U.S. Department
of Transportation

Ref. No. 01-0166

TO: Mr. Donald Burger
US DOT/ RSPA/ OHMS/ DHM-22.1
FAX NUMBER: (202) 366-3650
FROM: Marc Richardson, Taylor-Wharton
DATE: June 27, 2001
PAGES (including cover): 1
SUBJECT: DOT Interpretation of 49 CFR Requirements

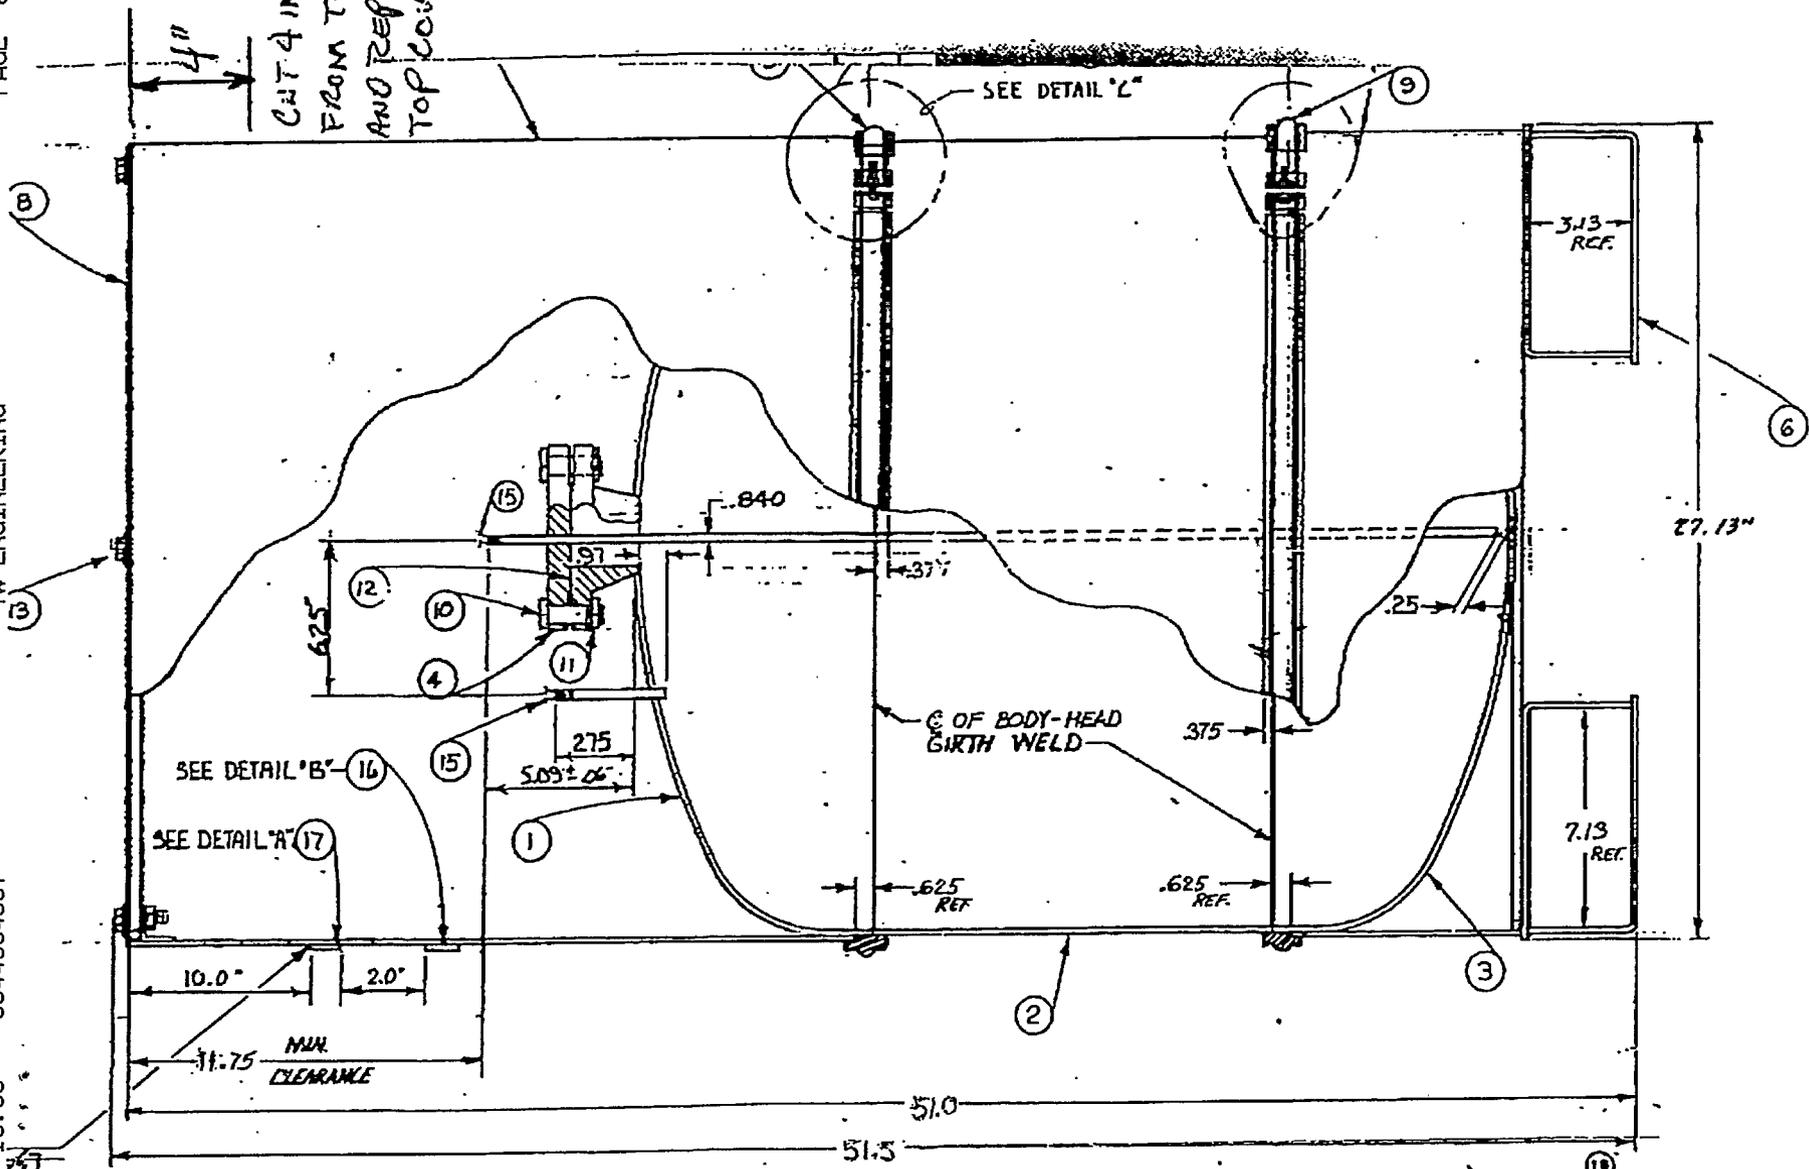
Ron Lambert, of Taylor-Wharton, contacted you last week concerning UN 1A1 cylinders that have been manufactured by Taylor-Wharton. In 1996 we changed the design by lowering the overall height by 5 inches. We now have a request from our customer to reduce the height of cylinders we built before the design change. We have a few questions concerning this modification of UN 1A1 cylinders. *drums*

Do we need to apply DOT Variation #3 or can we modify these old cylinders to match our latest approved design? *drums*

After the modification, do you leave on the current dataplate or do we need to use new dataplates that are required on our latest approved design?

What type of testing is required; completed design validation tests or just the period retesting?

CUT 4 INCHES FROM TOP SKIRT AND REFLACE TOP COVER

You may modify your existing drums from a tested design type to a similar, but shorter, design type without the need for additional testing as long as the modification will not reduce the structural integrity of the certified drum and the manner of construction for the modified drums is the same as for the tested design type. In addition, drum markings must accurately reflect the modified drums.
